#### IMPORTANT NOTICE

Please make the following changes in your ET-18 Technical Manual.

> Page 1 of 9 191-3163/ETW-18/EB-1801-30/595-2872-01 591-4163

#### Part 4 of 4

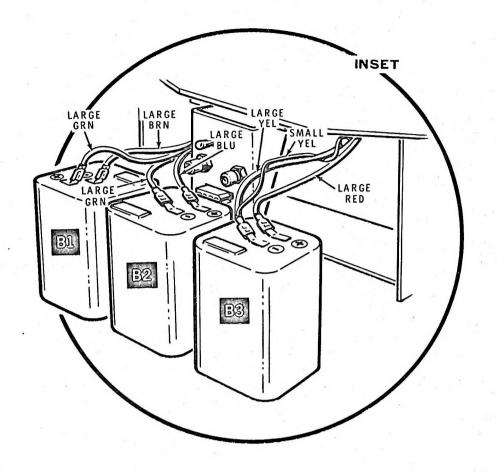
- Tape the new upper left section of the Display Circuit Board Schematic over the corresponding section.
- On the Display Circuit Board X-Ray View (upper left), cross out C1202, D1201, and R1202.

# SCHEMATIC OF THE SENSE CIRCUIT BOARD

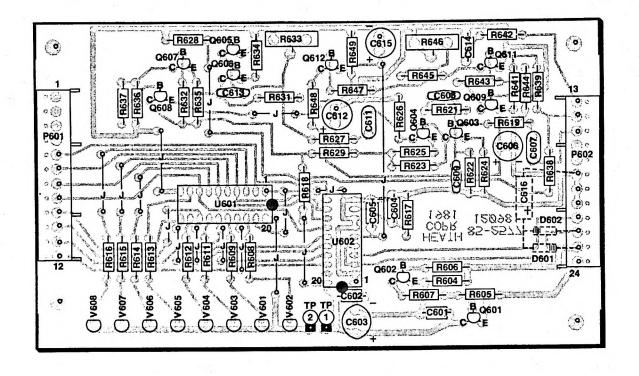
— In the center of the Sense Circuit Board Schematic.

Change:

R633

2M

To:

R633

1M

Change:

R618

47

To:

R618

10

- Tape the new upper left section of the Schematic supplied with this Notice over the corresponding section.
- Tape the new Sense Circuit Board X-Ray View, the Sonar Receive Circuit Board Schematic, and the Sonar Receive Circuit Board X-Ray View supplied with this Notice over the corresponding sections.
